DESCRIPTIVE REPORT

Registry No. FE-291

General Locality Seymour Canal

PACIFIC MARINE CENTER
EVALUATION REPORT
FE-291

H-10174 COPY OF SMOOTH SHEET
(prior survey sounding circled in red)

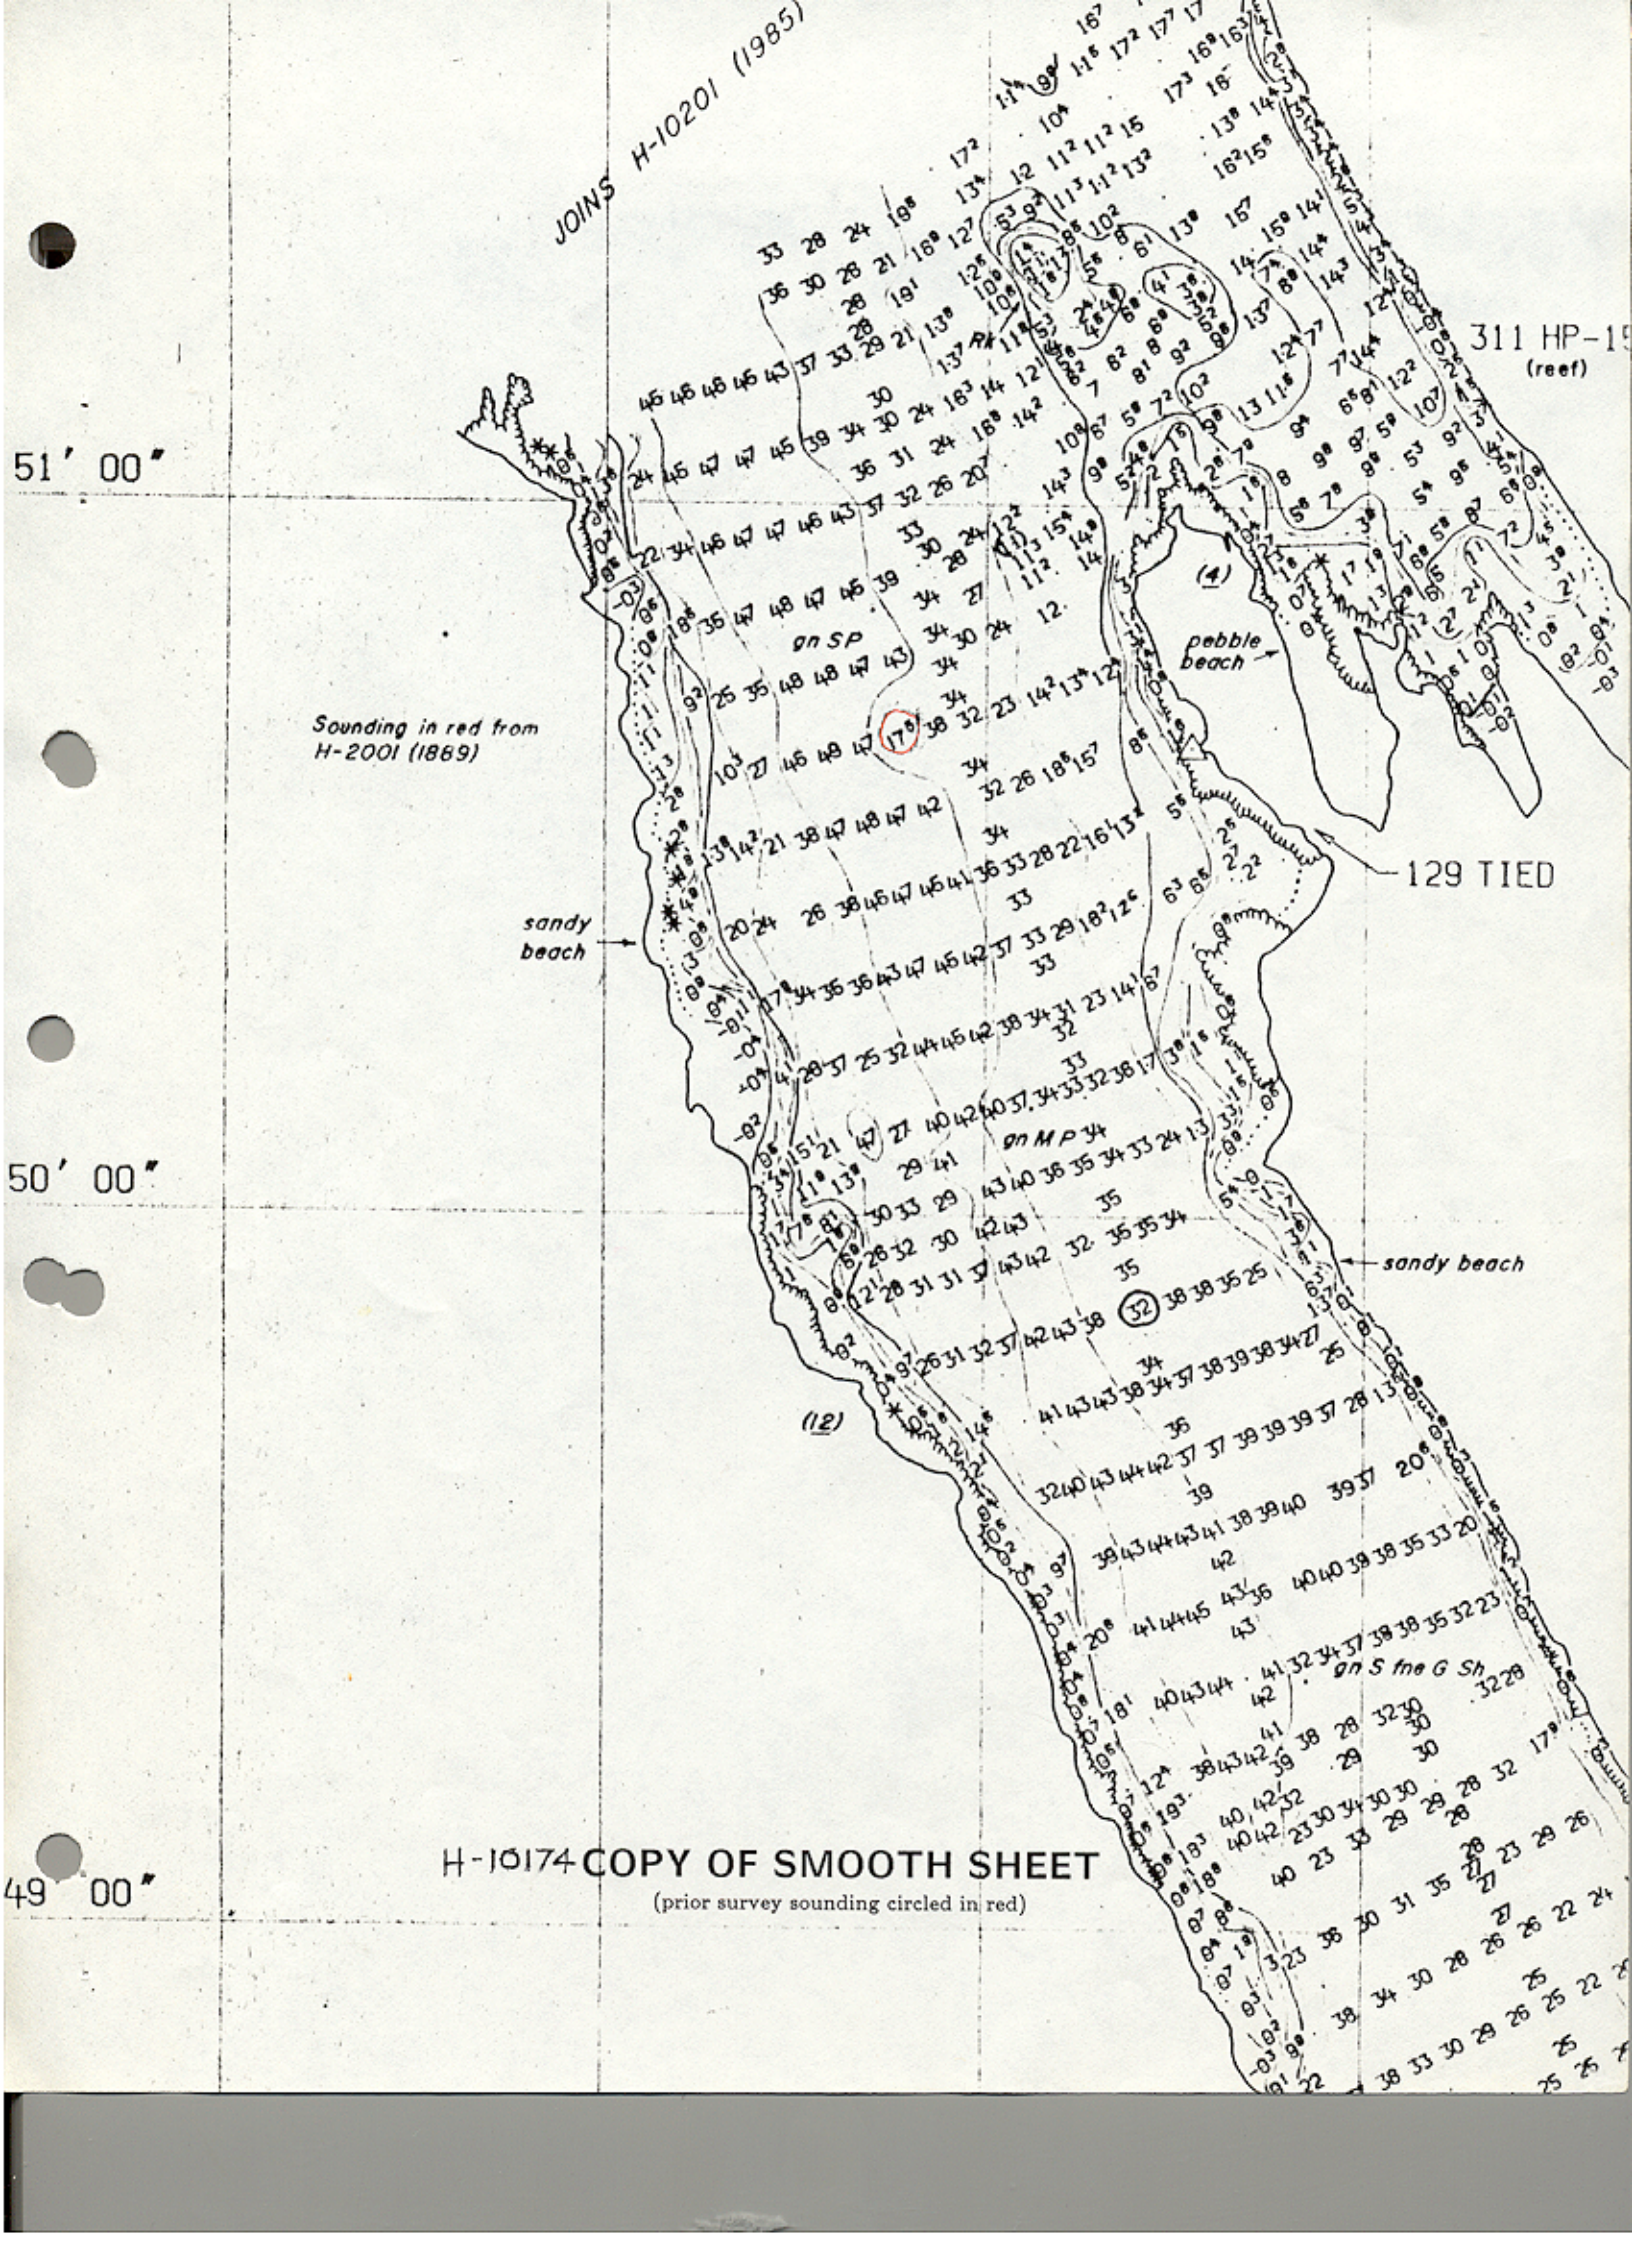
A prior survey sounding (17.5 fms) was brought through on the smooth sheet in an area where the RAINIER survey shows substantially deeper soundings (40 to 49 fms). This was the only offshore item marked, and was determined by RAINIER to be the only item requiring further work.

There is good agreement in soundings between the two surveys. The 17.5-fathom sounding at latitude 57°50'40"N, longitude 134°12'15"W in general depths of 43 to 46 fathoms which was carried forward to prior survey sheet H-10174 (1985) from H-2001 (1889) was not found in this survey. The present survey is adequate to disprove the existence of the the 17.5-fathom sounding from H-2001.

FE-291 disproves the existence of the 17.5-fathom sounding and may be used to supplement H-10174 if larger scale charting of the common area becomes necessary.
